THE LOCKE STREET MARKER **PUBLIC ART** PROJECT

Call for Artists **ADDENDUM NO. 1**

December 10, 2021

LOCKE STREET MARKER PUBLIC ART PROJECT
APPENDIX B - PUBLIC ART SITE CONTEXT MAP

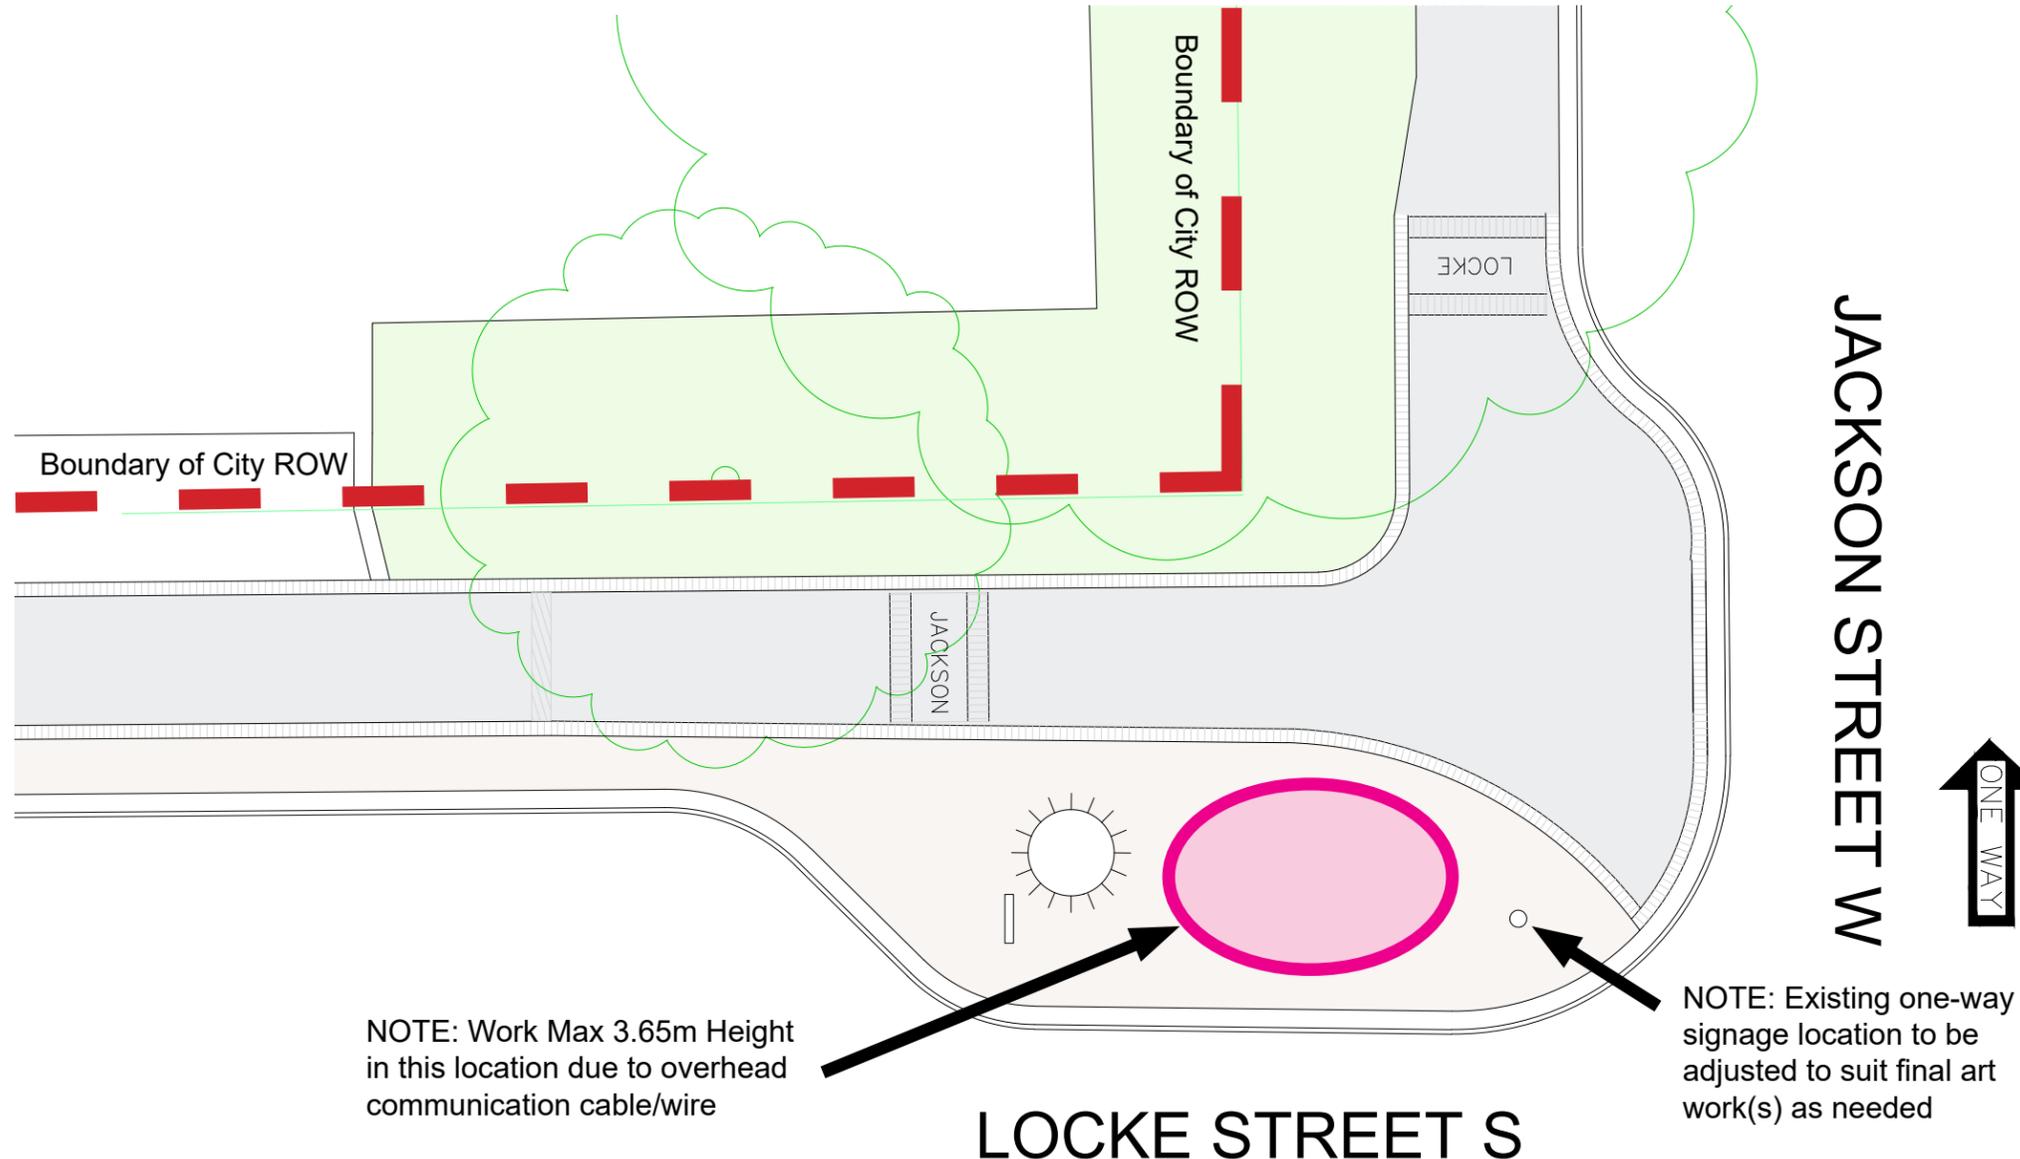
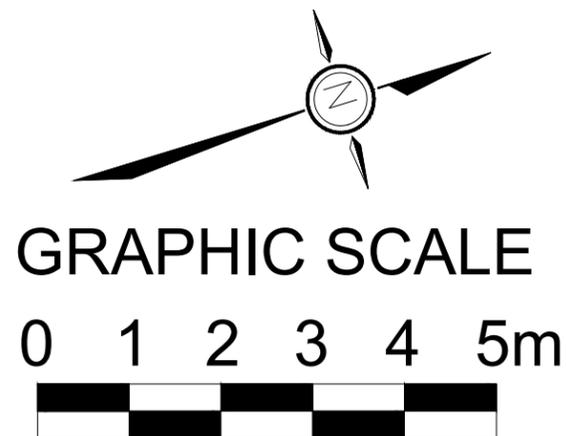
3.0 Under the Appendix B: Site and Context PDF Document delete page 4

And **replace with** the PDF on page 2 (below)

NOTE:
 Appendix B updated Dec 13, 2021 as part of Addendum #1

The work(s) must be located within the public road Right of Way (ROW) along Locke Street S at Jackson Street W (See plan to left) in accordance with the following requirements:

- The work(s) shall be located within the ROW generally centered within the concrete bumpout.
- All objects must be 450mm from street side of the curb.
- Work shall be located in such a way as to maintain a clear pedestrian path on the sidewalk of minimum 1.5m in width.

- No work shall impede pedestrian movement north and south along the sidewalk, at corners or at designated pedestrian crossing locations.
- Any work shall be limited in length along the street so as not to become a wall between the sidewalk and the street and to allow access to the sidewalk from the street for pedestrians and parked car doors.

- All work shall be designed and located in such a way as to provide a minimum clearance of 2.0 metres between itself and all other pieces on the street as well as existing street infrastructure such as hydro poles and streets signs to allow for the passage of snow clearing equipment.

- The work must not obstruct the view of existing attachments (traffic lights, traffic signs, bus stops etc.) and not impact traffic safety in any manner.

- Any work proposed shall not have any ledges, surfaces or other features that will allow for climbing.
- No work may be attached to utility poles
- Work cannot cover existing utilities

- The work must be designed in a way that it can be removed and reinstalled by City staff or contractors if site conditions change in the future.
